**San Francisco Public Utilities Commission**  
**Peninsula Pipelines Seismic Upgrade Project**  
San Mateo County, California

**Responses to Comments on**  
**Draft Environmental Impact Report**

**San Francisco Planning Department Case No. 2011.0123E**

**Re:** **Attached Responses to Comments on Draft Environmental Impact Report Case No. 2011.0123E, Peninsula Pipelines Seismic Upgrade Project**

**FIGURE RTC 4-1 (REVISED FIGURE 3-2)**

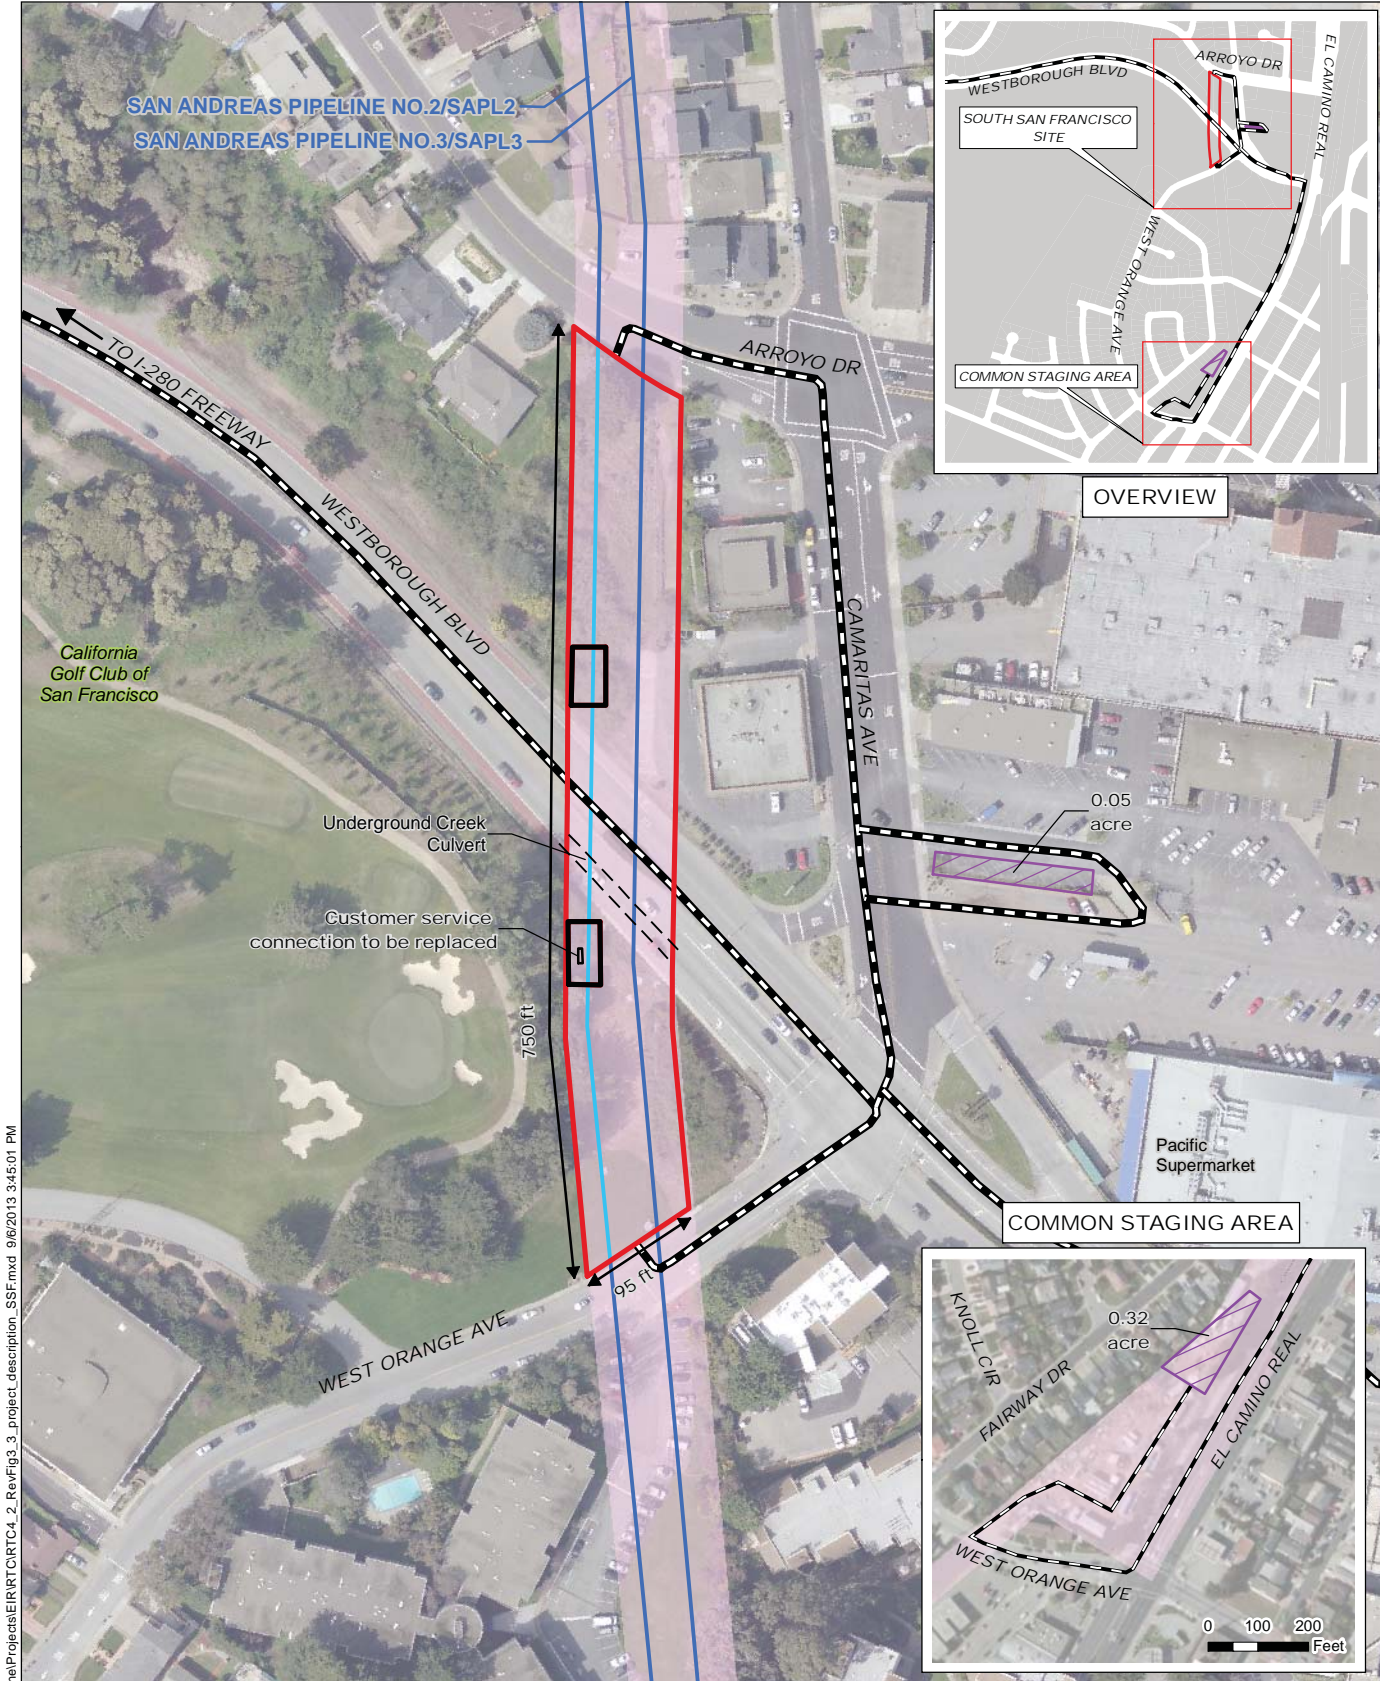
Figures 3-2 and 3-3 of the Draft EIR show wholesale customer service connections to be replaced at the Colma and South San Francisco sites; these figures have been updated to more accurately show the scale of the turnout replacement dimensions. Figure 3-5 has been revised to show the customer service connection to be replaced. Similarly, Figures 3-7 and 3-9 through 3-10 have been revised to show the customer service connections to be replaced (plan and profile views). The revised figures are provided in this document in Section 4.2, Figure Revisions.

- Figure 3-2, Colma Site, on page 3-4, in Section 3.1, Project Location, has been revised to more accurately show the scale of the wholesale customer service turnout replacement dimensions, as shown in Figure RTC 4-1.

**FIGURE RTC 4-2 (REVISED FIGURE 3-3)**

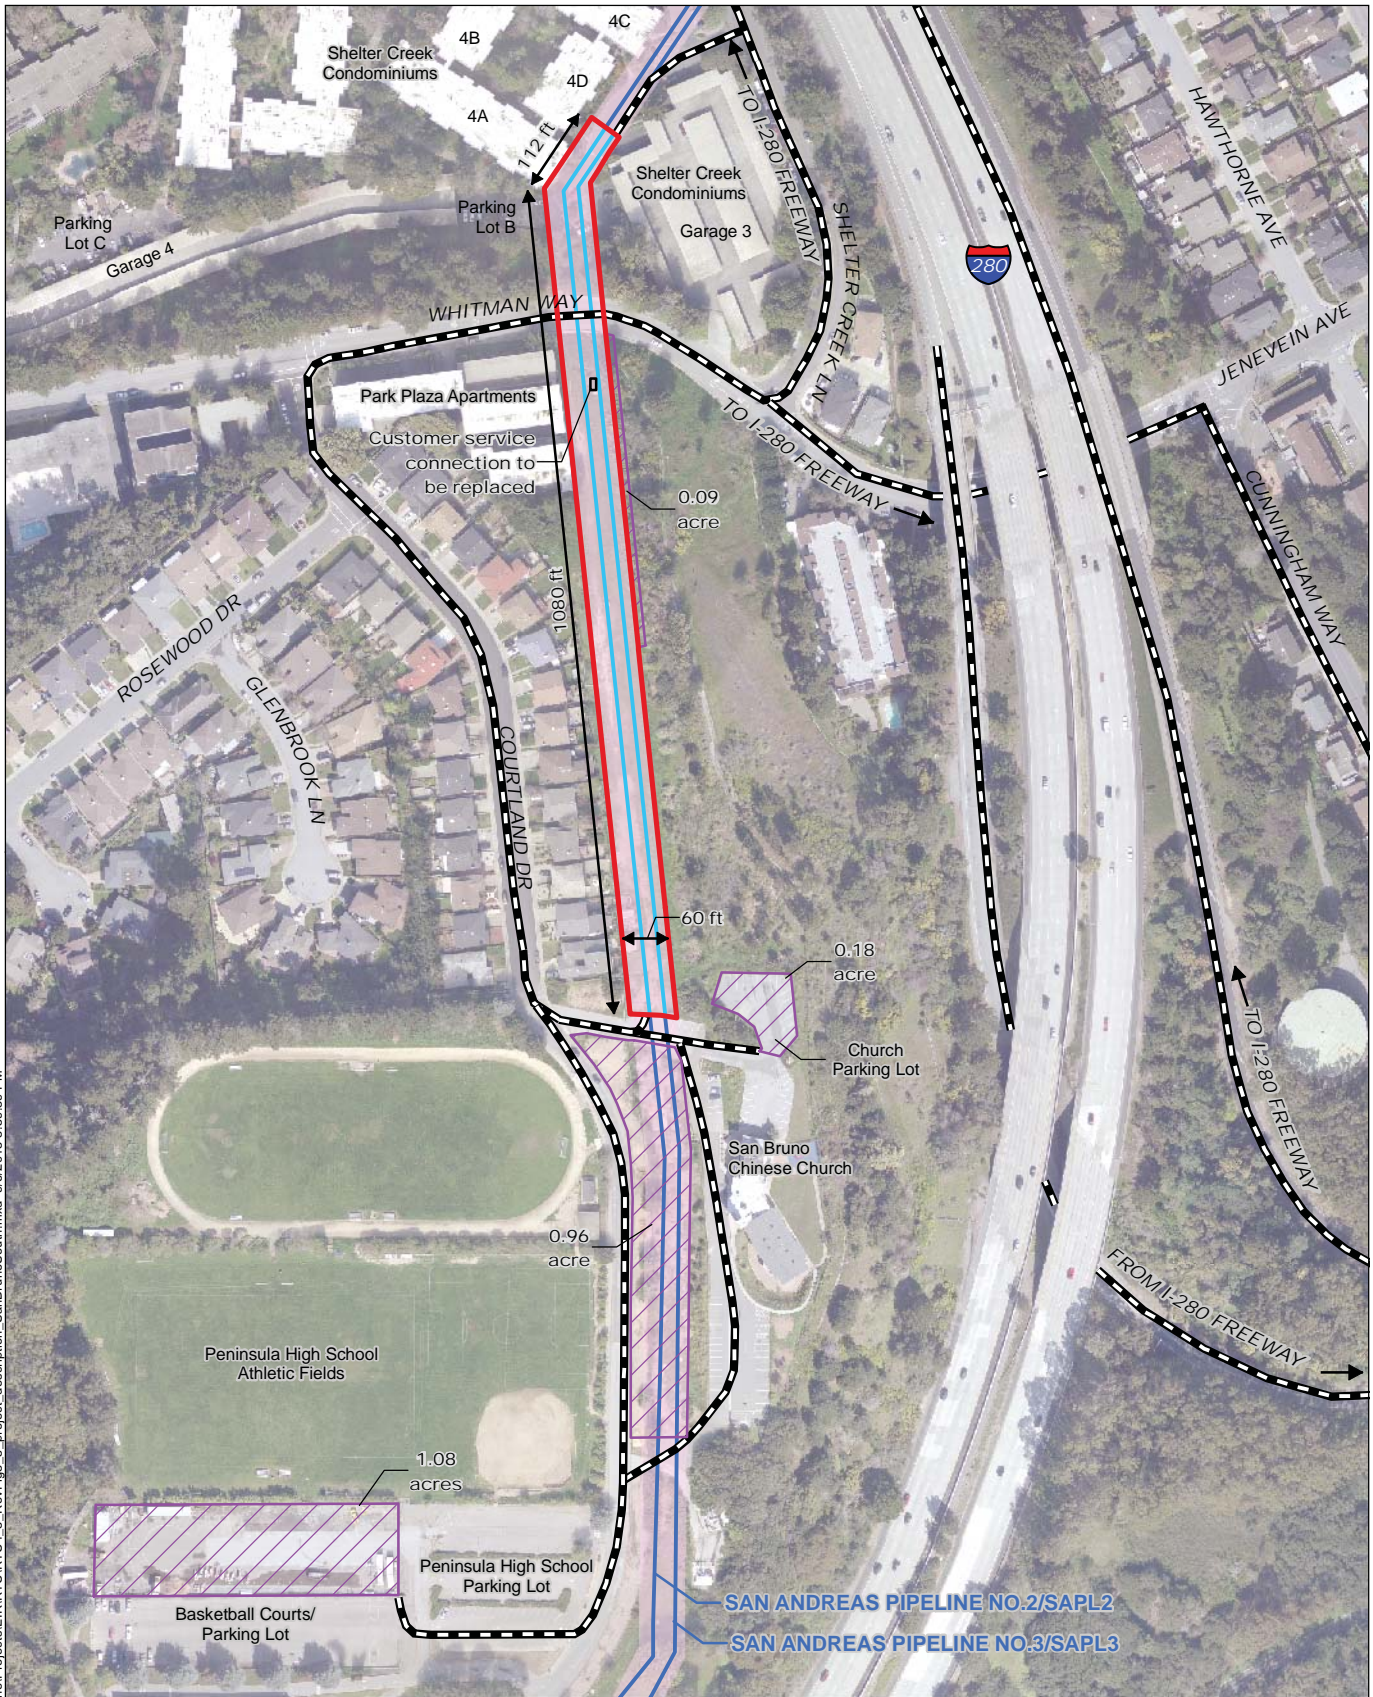
- Figure 3-3, South San Francisco Site, on page 3-5, in Section 3.1, Project Location, has been revised to more accurately show the scale of the wholesale customer service turnout replacement dimensions, as shown in Figure RTC 4-2.

**FIGURE RTC 4-4 (REVISED FIGURE 3-7)**

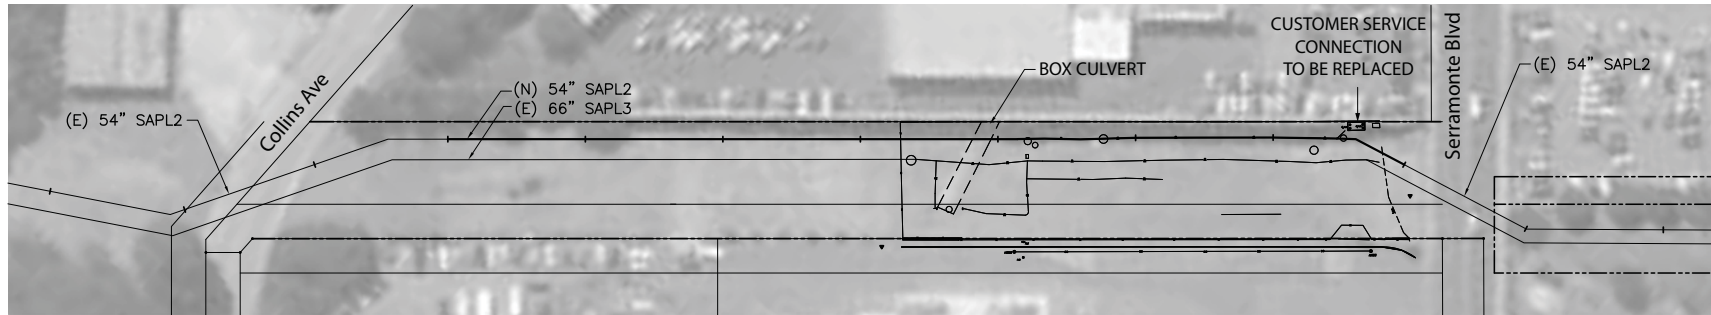
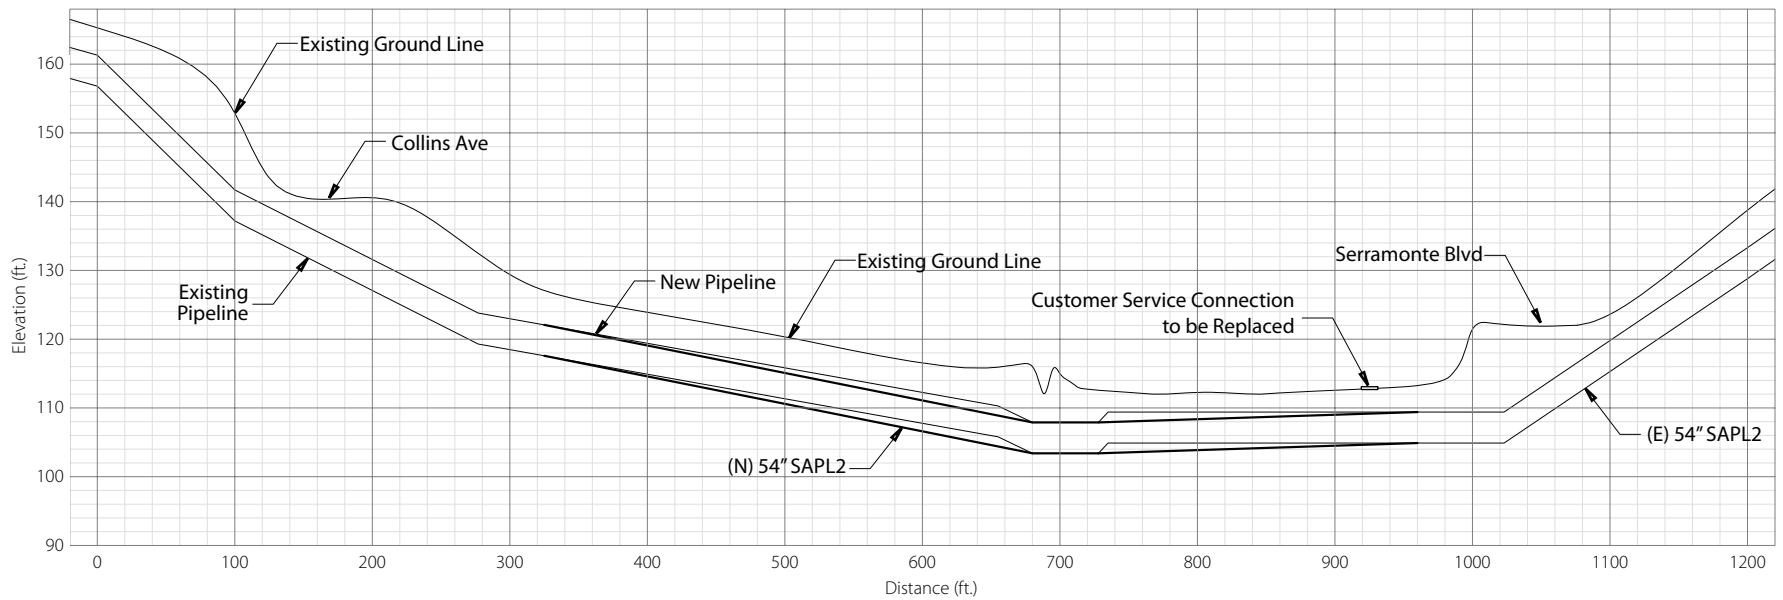
- Figure 3-7, Colma Plan and Profile, on page 3-15, in Section 3.5, Proposed Project, has been revised to show the wholesale customer service turnout to be replaced, as shown in Figure RTC 4-4.

**FIGURE RTC 4-5 (REVISED FIGURE 3-8)**

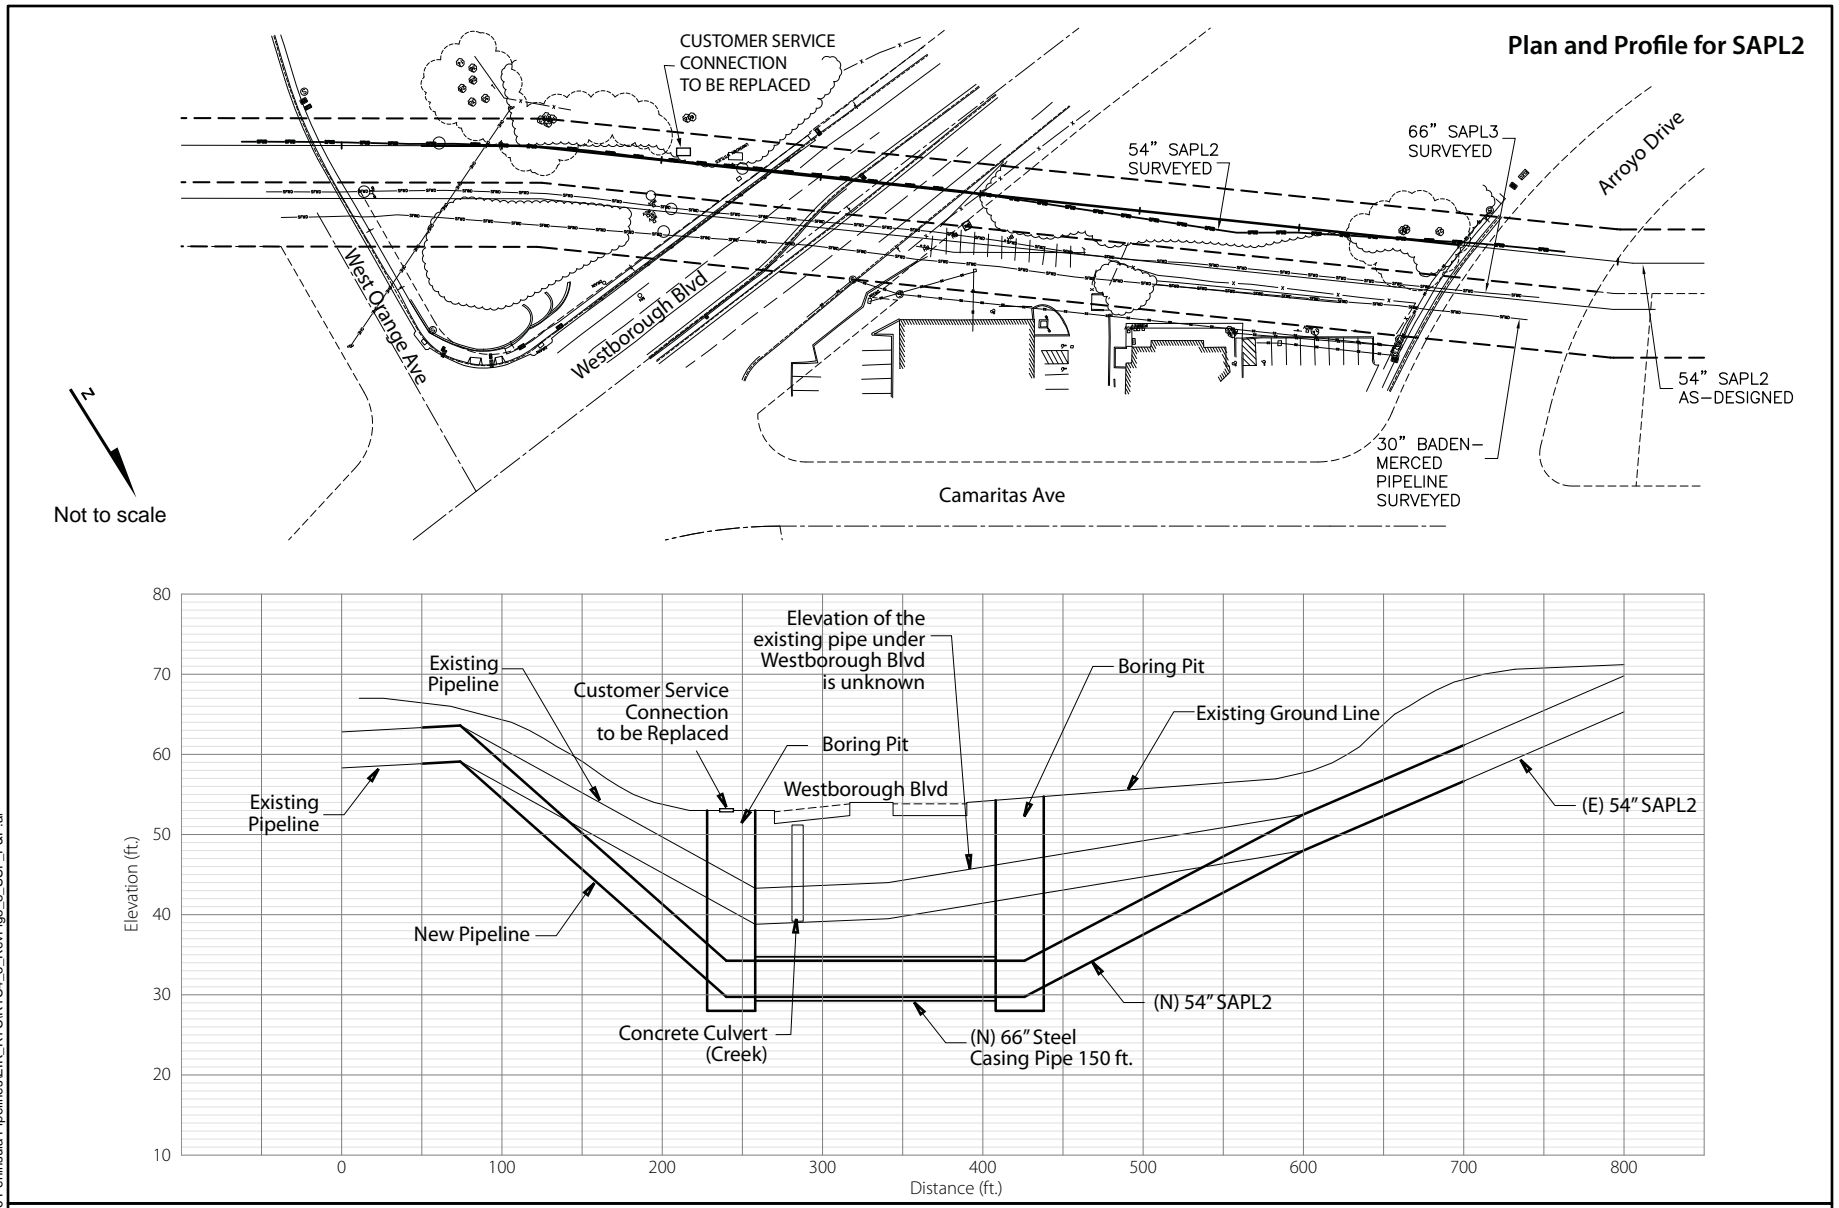
- Figure 3-8, South San Francisco Plan and Profile, on page 3-17, in Section 3.5, Proposed Project, has been revised to show the wholesale customer service turnout to be replaced, as shown in Figure RTC 4-5.

**FIGURE RTC 4-6 (REVISED FIGURE 3-10)**

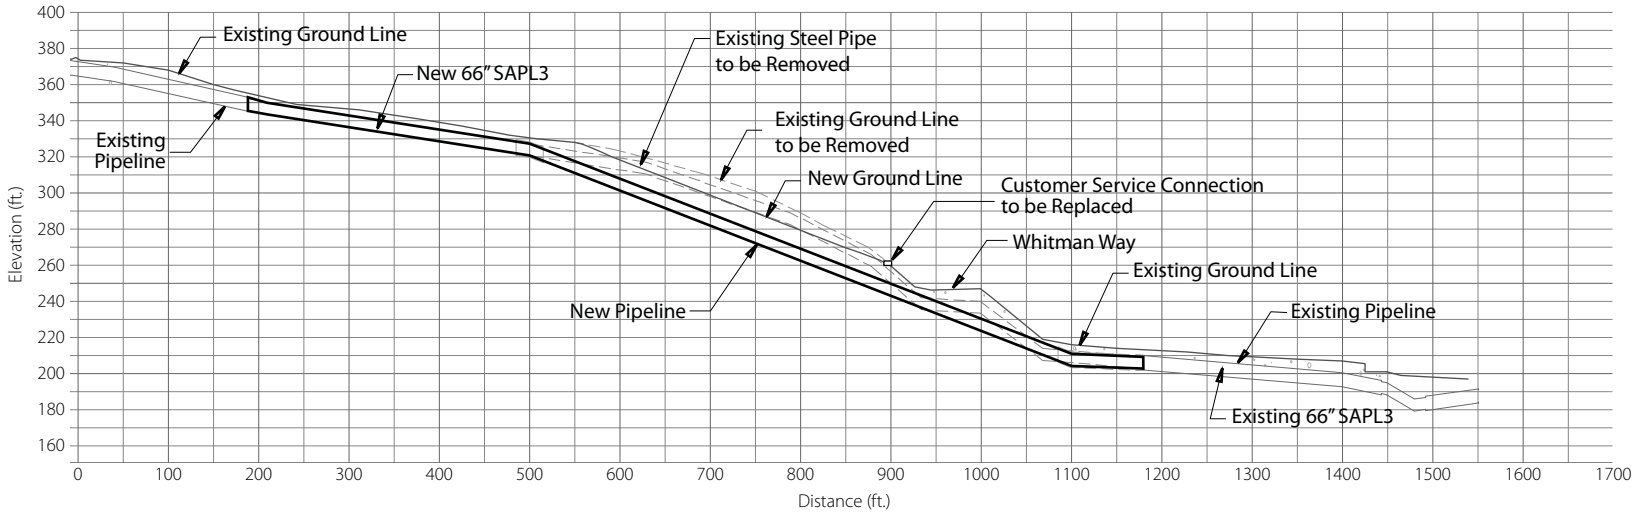
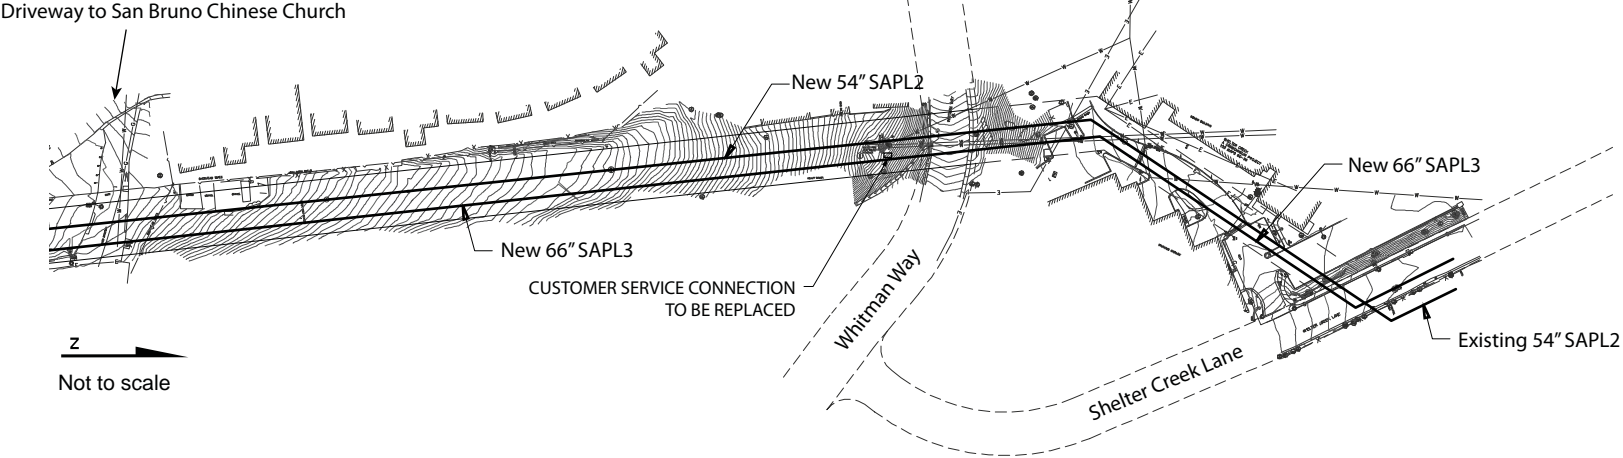
- Figure 3-10, San Bruno South Plan and Profile, on page 3-20, in Section 3.5, Proposed Project, has been revised to show the wholesale customer service turnout to be replaced, as shown in Figure RTC 4-6.
